Groundwater Application Review Summary Form

Application # G- 18555

GW Reviewer Phil Marcy Date Review Completed: 5/9/2018

Water-Level Trends in Nearby Wells

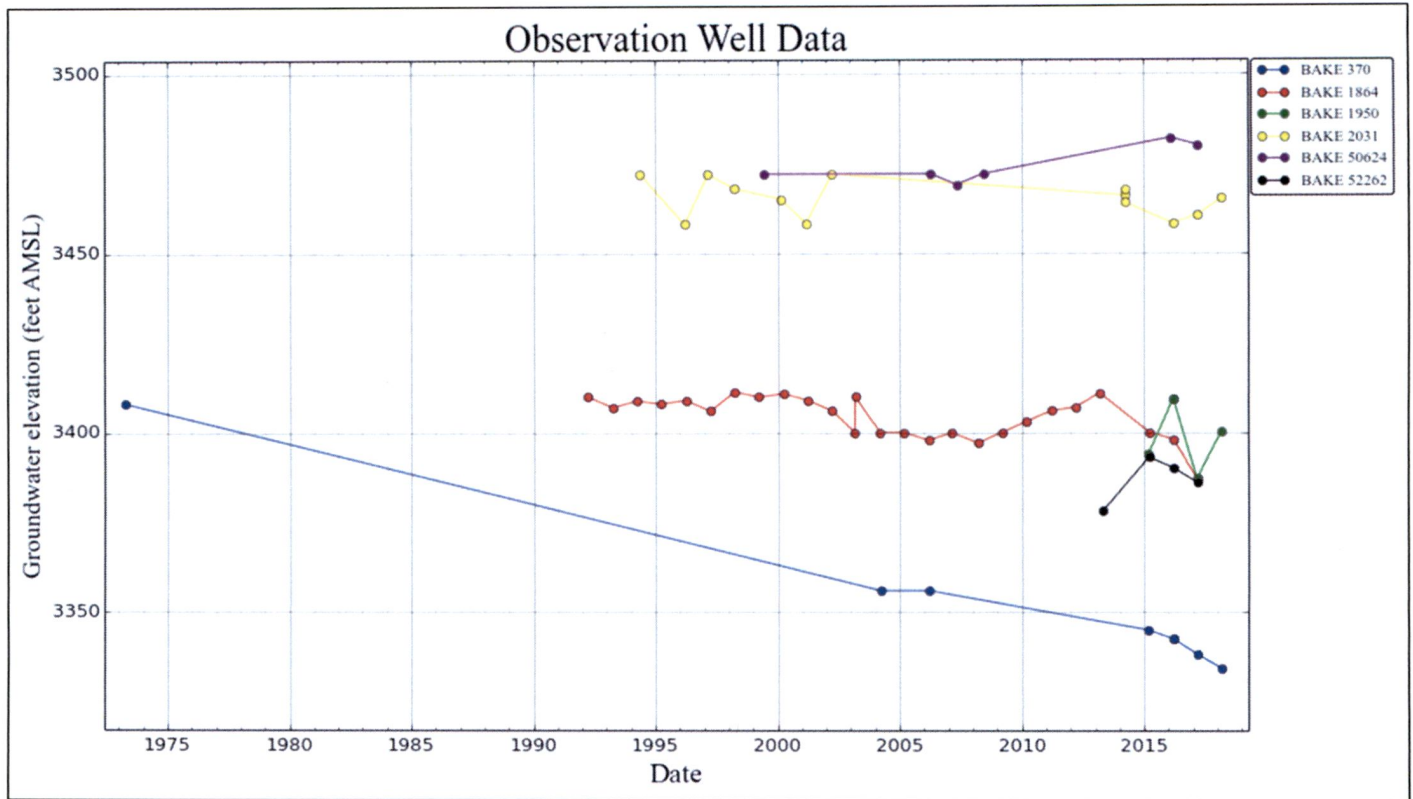
Water levels in wells to the east and northeast are relatively stable (see attached hydrograph) , but declines become more pronounced further from the head of the alluvial fan where the proposed POA is located. A greater percentage of fine-grained, low permeability material is encountered downslope as well, leading to the deepening of some nearby irrigation wells. In each case, the pre-deepening and post-deepening static water level is reported as the same, indicating that the aquifer system is well-connected overall and represents a single unconfined aquifer in equilibrium with atmospheric pressure.

Water level data from nearby wells (see attached map for locations), unfortunately no observation wells exist within one mile of the proposed POA well. Cross-sections of lithology and construction display that these wells are completed in a similar fashion, though some have been deepened without any significant change in head elevation. In map view, a distinct trend emerges with heads decreasing toward the northeast, away from the head of the alluvial fan that the proposed POA well is located on.
